Re: Northern Indiana Public Service Company  
Bailly Generating Station - Nuclear 1  
Docket No. 50-367

RESPONSE TO NRC REQUESTS FOR INFORMATION

OF JUNE 28, 1979

FIGURE 1 - 12

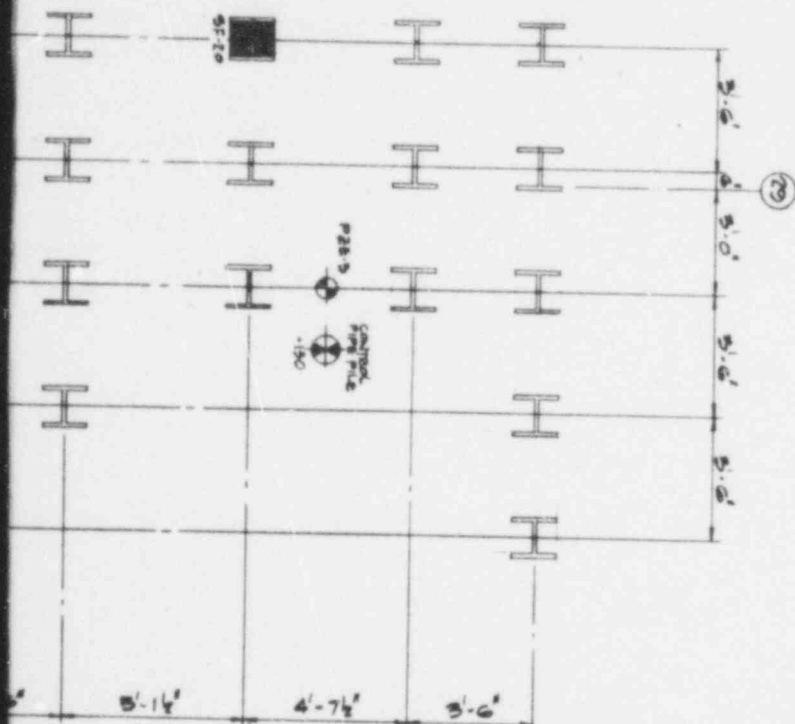
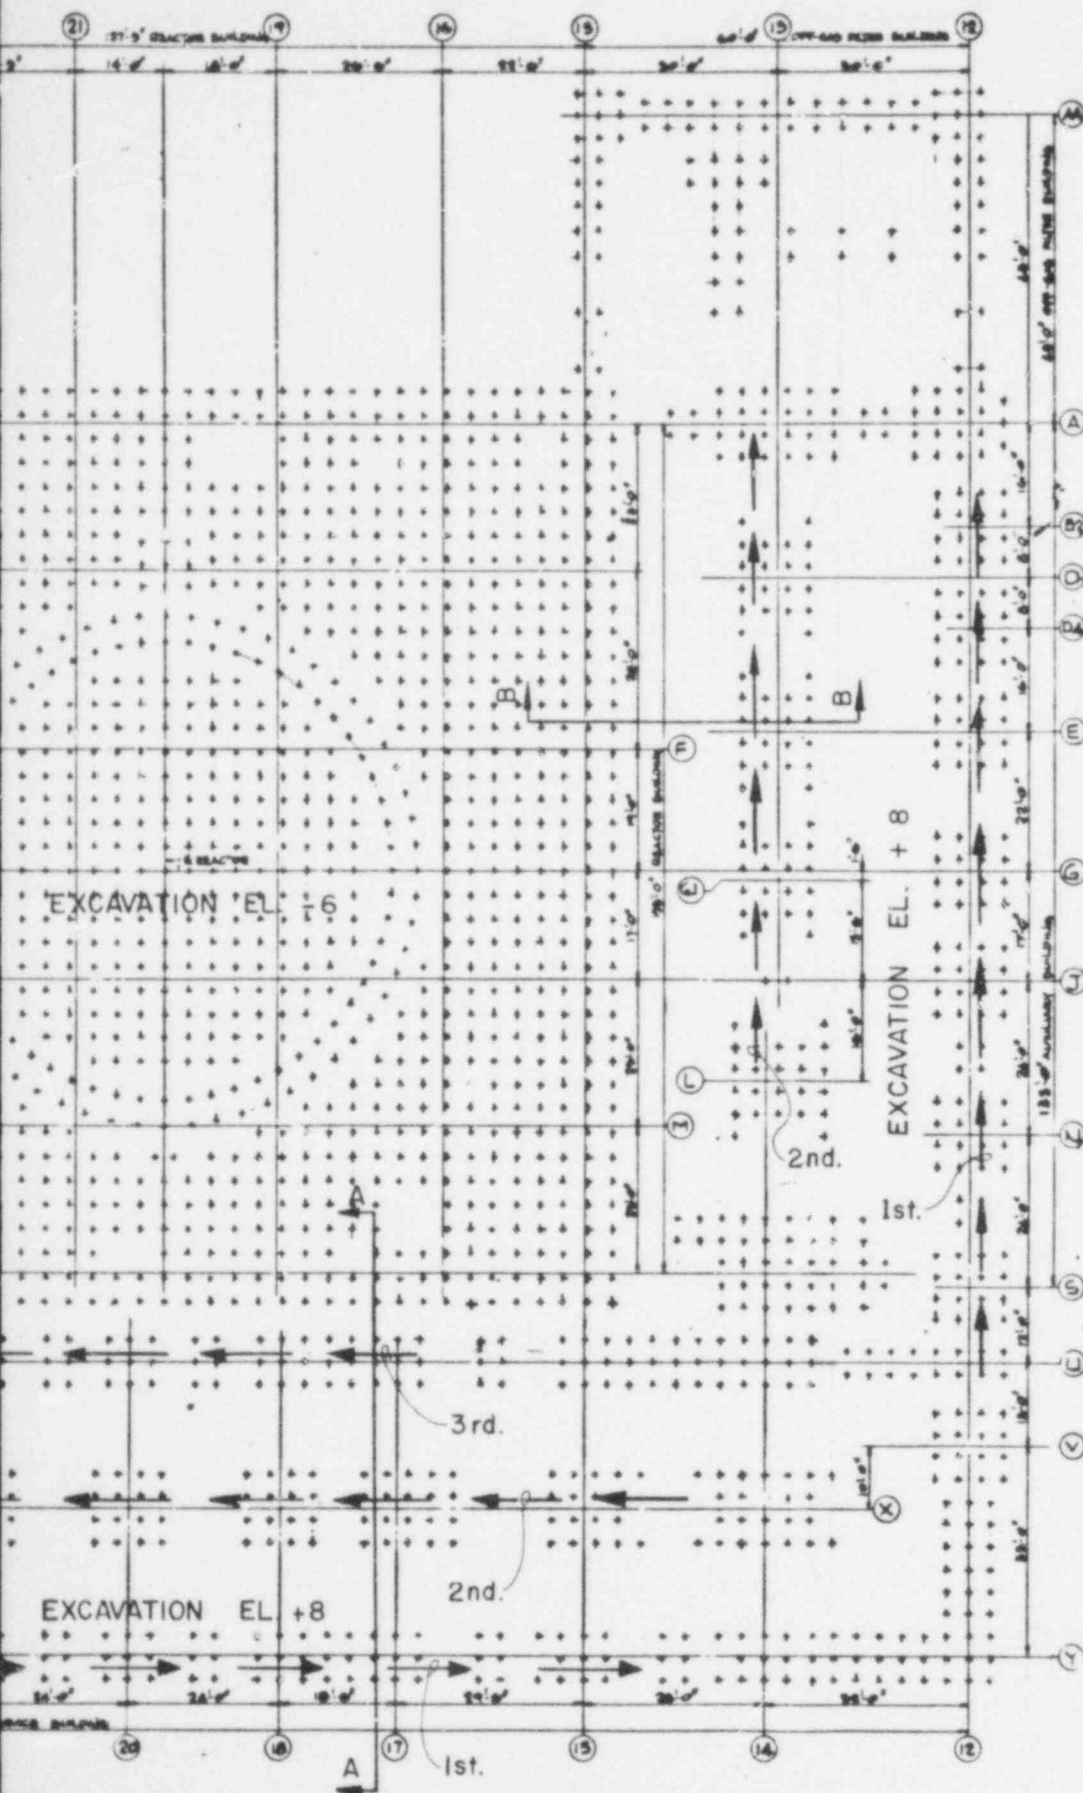
#### 1.3.5 Preconstruction Area E (Figure 1-12)

- a) No supplementary borings will be drilled in area E because a sufficient number of borings have already been drilled to define the disturbance in this area. However, as explained earlier, the cone penetrometer will be used in an effort to develop site-specific information as to the suitability of this device as an independent means of evaluating the effectiveness of the densification program.

The cone penetrometer will be used in this area primarily to calibrate the device for the soil conditions existing at the Bailly site. One sounding will be performed adjacent to each of the existing borings PZE-1 to PZE-4. As explained in Reference 1, borings PZE-1 to PZE-4 cover the range of soil conditions in the preconstruction areas from severe disturbance (PZE-4) to no disturbance (PZE-3). In addition, cone soundings will be taken within 2 feet of one or two of the jetted piles and in the area densified by the H-piles driven as part of the

- b) Two control pipe piles will be driven at the locations shown in Figure 1-12. The first pipe pile will be located near boring PZE-3, which showed no signs of disturbance. The second pipe pile will be driven next to pile SF-66, which met the driving criteria.
- c) Additional densification piles will be driven north and west of the jetted piles, as shown in Figure 1-12, because of the disturbance identified in borings PZE-1 and PZE-2, and indicator pile SF-34.
- d) Two verification borings will be drilled close to borings PZE-1 and PZE-2 to evaluate the effectiveness of the densification program.

FIGURE 3 - I

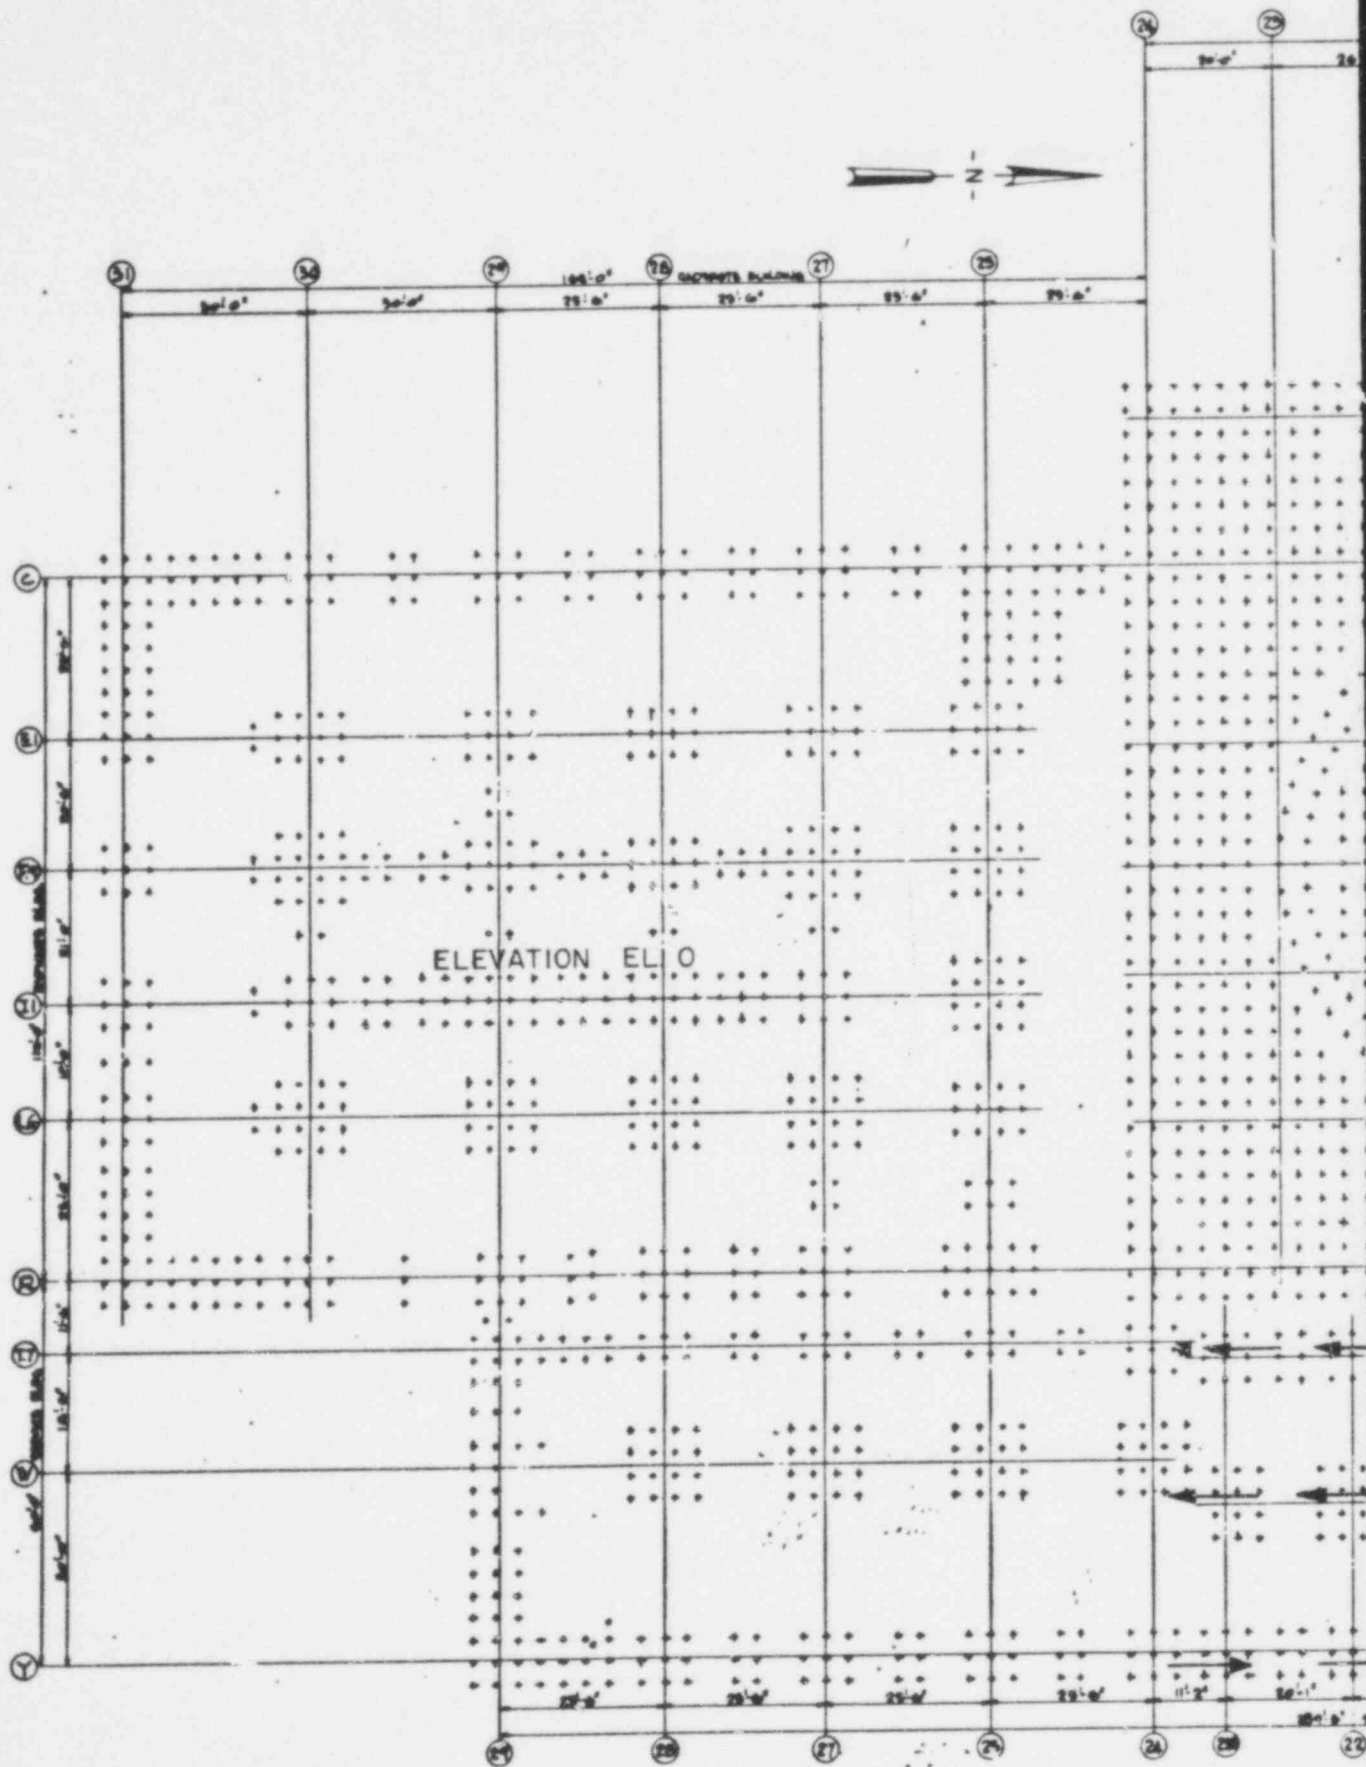
To demonstrate these procedures, the excavation and pile driving sequence for two areas has been detailed. (See attached plan view, Figure 3-1.) Brief descriptions of the sequence for each section follow.

- 1) the excavation will be completed prior to driving production piles located adjacent to slopes and
- 2) the pile driving sequence is planned so that the pile driving operations will always progress towards the slope.

FIGURE 3 - 2

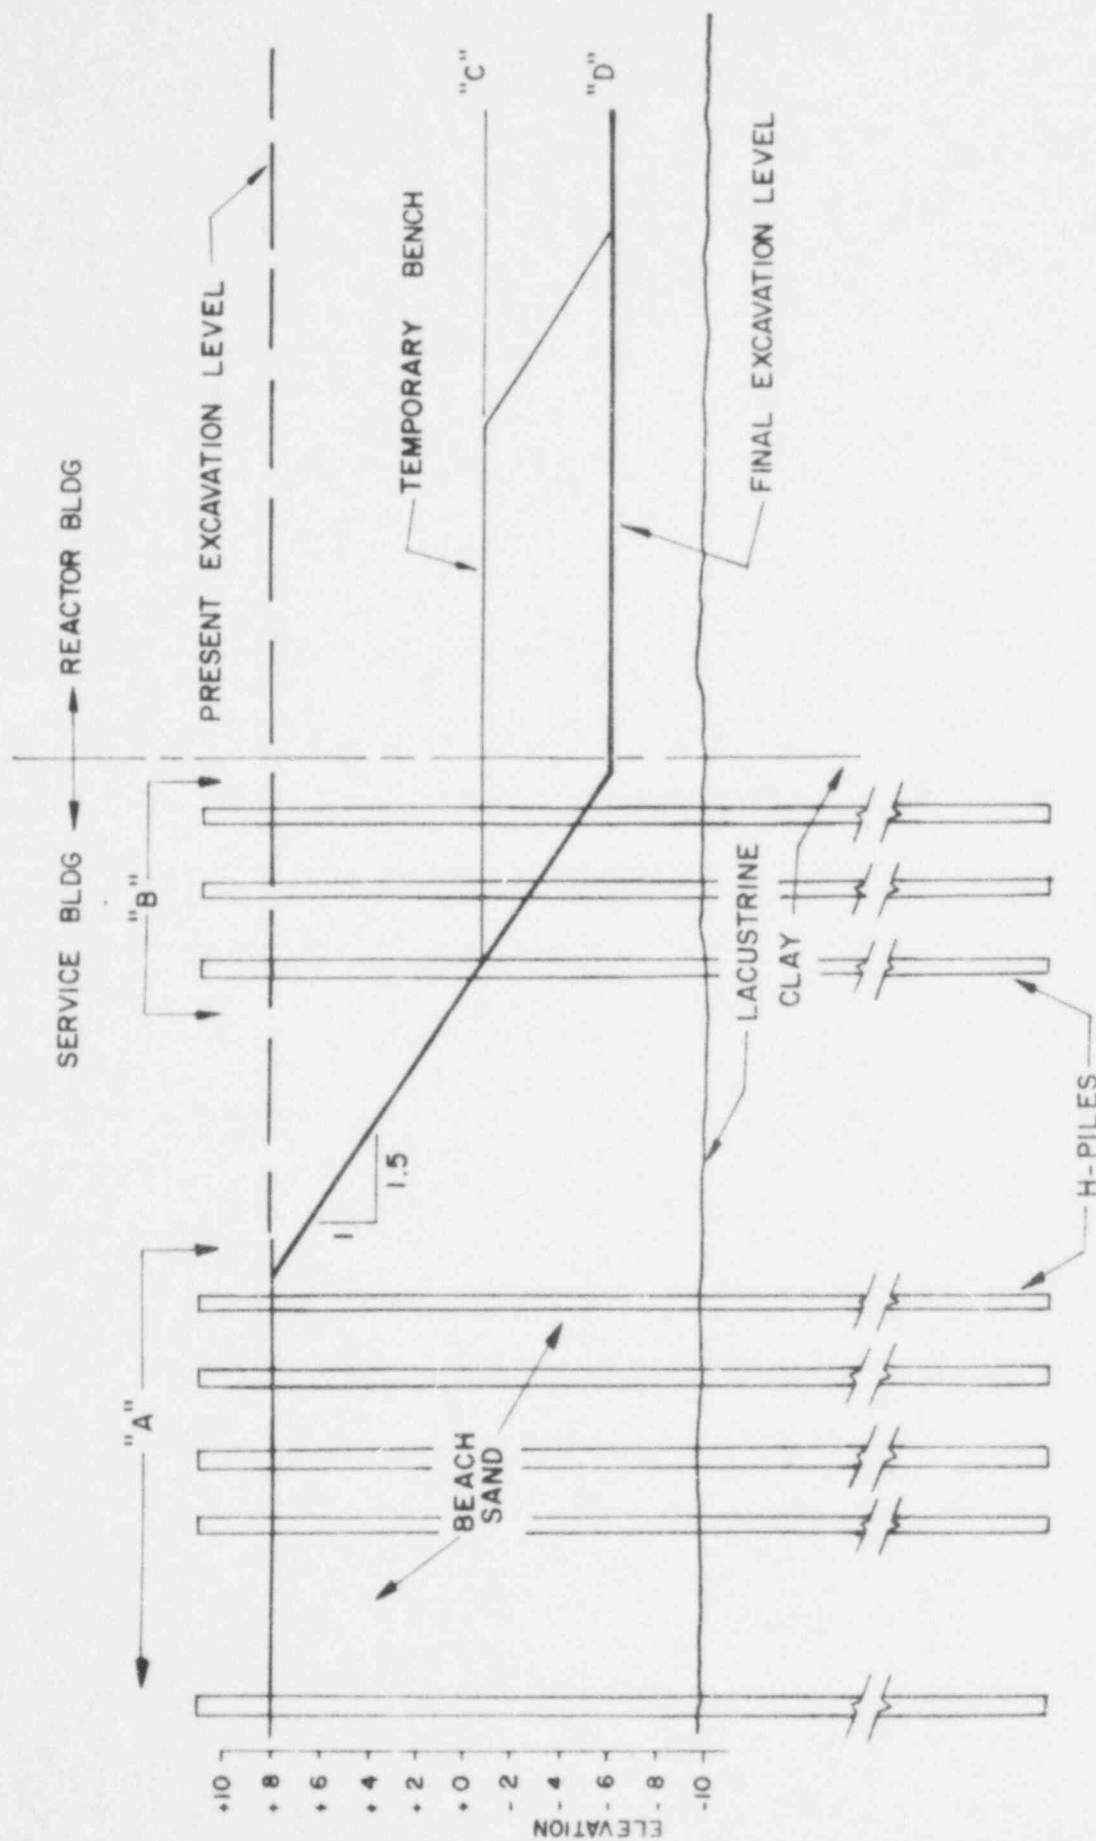
Figure 3-2 presents a cross section in the east-west direction showing the slope configuration between the Service Building (final excavation level at elevation +8) and the Reactor Building (final excavation level at elevation -6). The sequence of excavation and pile driving operations is described below.

1. Excavate Reactor Building area to elevation -6. Leave temporary bench ("C") at elevation -1 to allow access for redrive of easternmost Service Building heaved piles (if any) and to drive piles identified as group "B".

2. Drive Service Building piles from El. +8 starting from the easternmost rows and moving west. The westernmost pile groups, labeled "B", will be driven last from bench "C" at elevation -1.
3. After the Service Building piles are driven and checked for heave (and all necessary redrive completed), remove bench "C" down to El. -6 ("D").

FIGURE 3 - 3

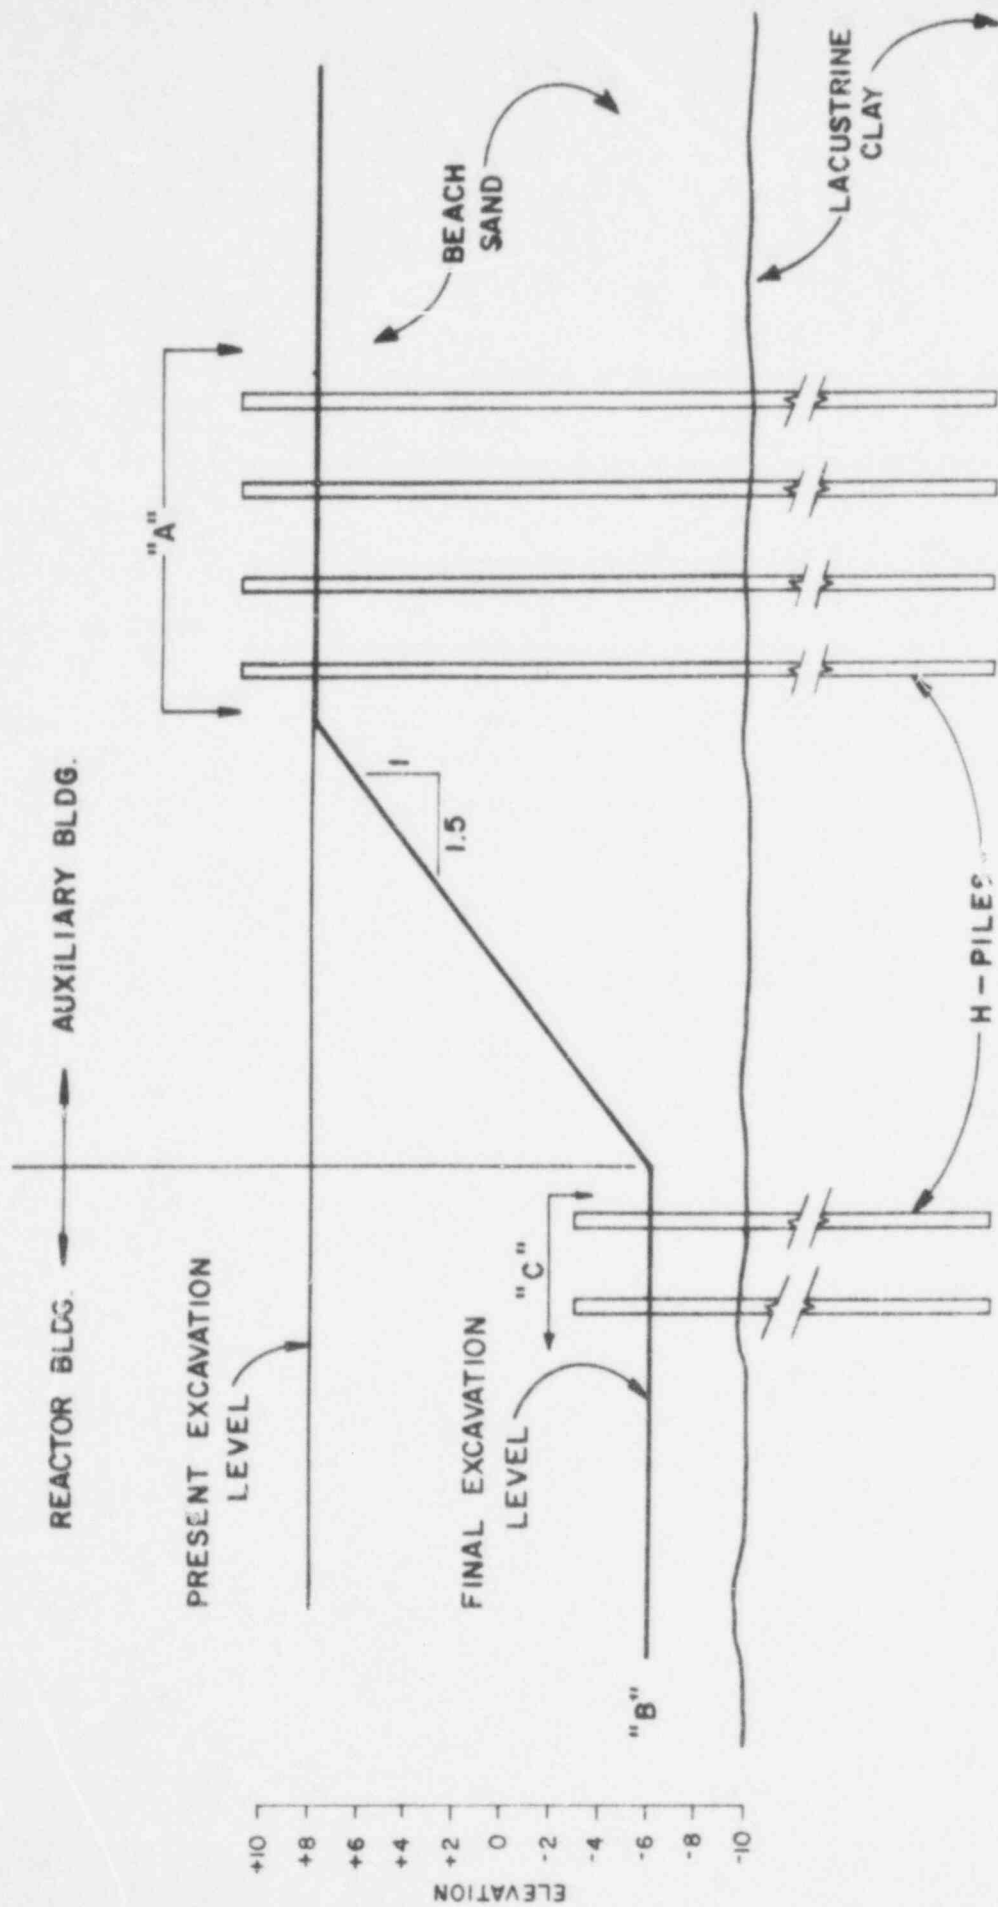
Figure 3-3 presents a cross section in the north-south direction showing the slope configuration between the Auxiliary Building (final excavation level at elevation +8) and the Reactor Building (final excavation level at elevation -6). The sequence of excavation and pile driving operations in this area is described below.

1. Excavate the Reactor Building area to elevation -6 ("B").
2. Drive Auxiliary Building H-piles starting from the east end of the building and working west as indicated by the arrows in Figure 3-1. It should be noted that the pile groups labeled "A", adjacent to the slope, will be driven last.
3. Drive Reactor Building H-piles ("C").
